SID TRUNCATION REQUEST (ACP-2020-052) – SUBMISSION DATE:

Existing SID: EGKK CLN 1M 1V 5P 5W

Proposed SID: EGKK FRANE 1M 1V 1P 1W

AD 2.EGKK-6-7 (Original).

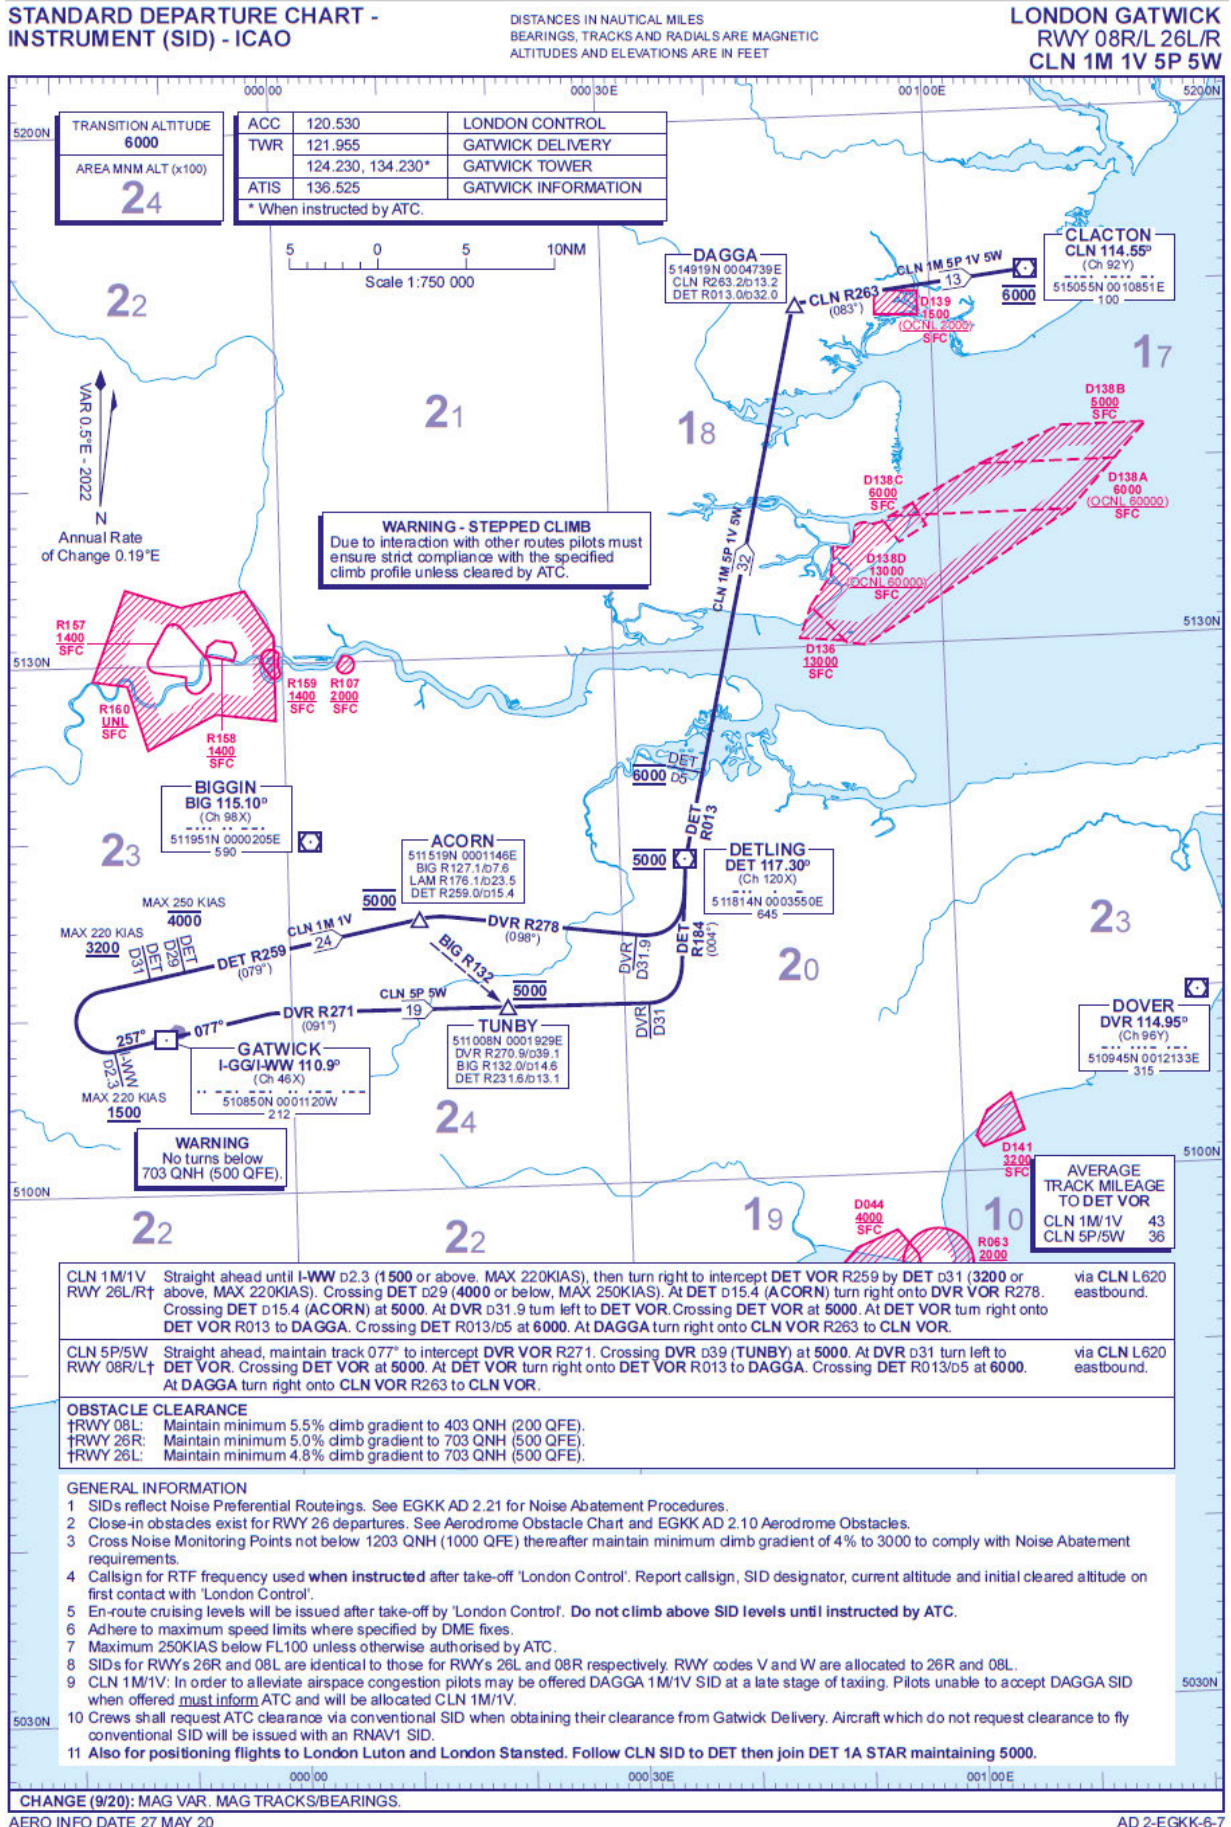
AD 2.EGKK-6-7: INSTRUMENT (SID) RWY 08R/L 26L/R CLN 1M 1V 5P 5W will be replaced with: INSTRUMENT (SID) RWY 08R/L 26L/R FRANE 1M 1V 1P 1W
